**Before the
FEDERAL COMMUNICATIONS COMMISSION
Washington, D.C. 20554**

REPLY TO OPPOSITION TO PETITIONS TO DENY

Errors and Issues in the Testing and Certification of the ReconRobotics Recon Scout

Figure 1 - This graph from the test-result report shows the measured bandwidth of the Scout when operated on with an apparent video carrier at 445 MHz.

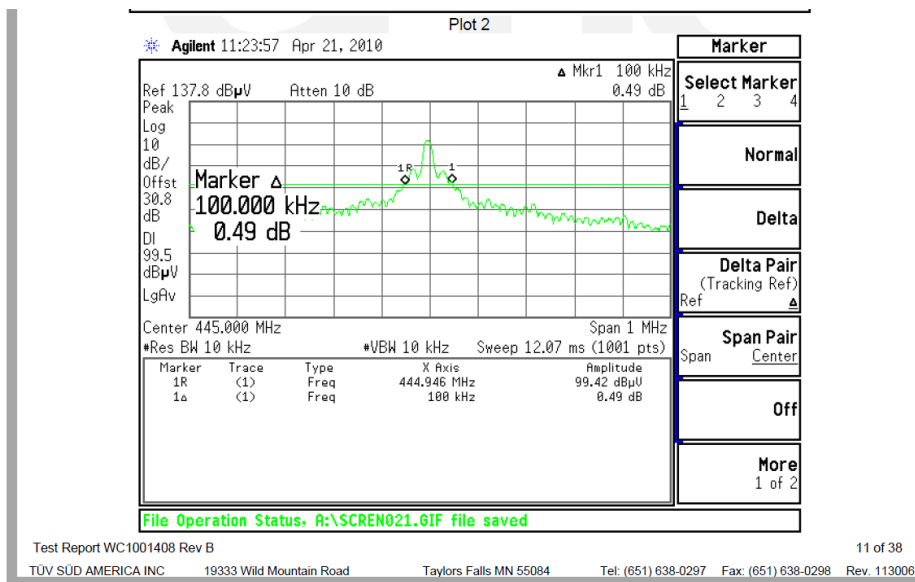
Figure 1 below, taken from the ReconRobotics Scout test-result report, shows the reported occupied bandwidth of the transmitter. This measurement is by no means representative of the bandwidth of an NTSC analog video signal. Part 2 is not explicit as to the modulation test conditions for a transmitter using C3F emissions, but the loosest possible interpretation of the rules would allow the use of the provision of §2.1049(i):

The test conditions that existed when the occupied bandwidth measurement of Figure 1 was taken were neither typical nor a reasonable representation of the occupied bandwidth that would be encountered in actual use. Figures 2 and 3 below show measurements of

What is evident from the comparison of the bandwidth of the signal transmitted during the testing of the Scout and the bandwidth of the two extremes of the ranges seen in Figures 2 and 3 above is that the modulation of the Scout was not close to the modulation that would produce a reasonable representation of the range of occupied bandwidth that would be seen during typical operation of the device under test. This is another area where the test result report does not support a certification grant, and therefore the applications that specified the erroneous emission designator in the certification grant are in error as well.

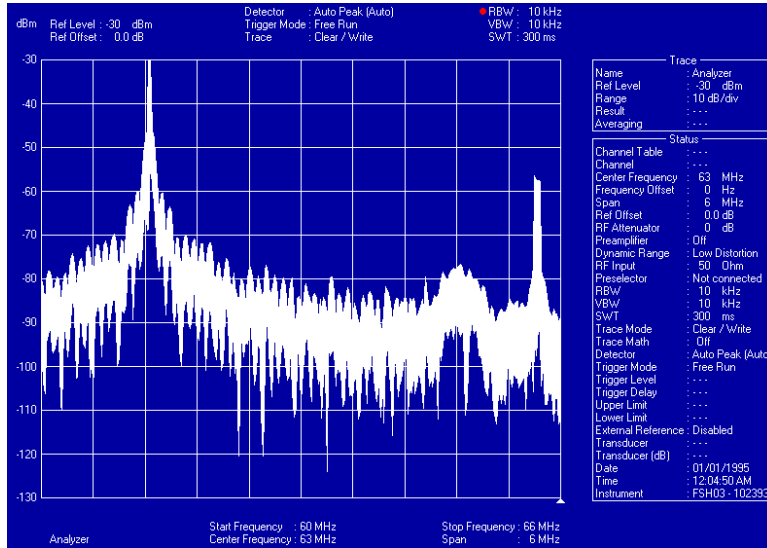
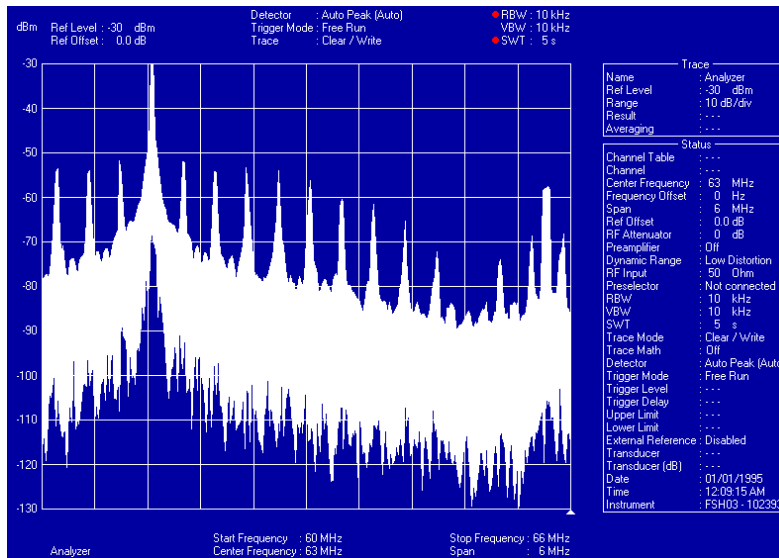
the RF output of an NTSC generator under two modulation conditions – a blank raster and a crosshatch. The crosshatch is a common video test signal.
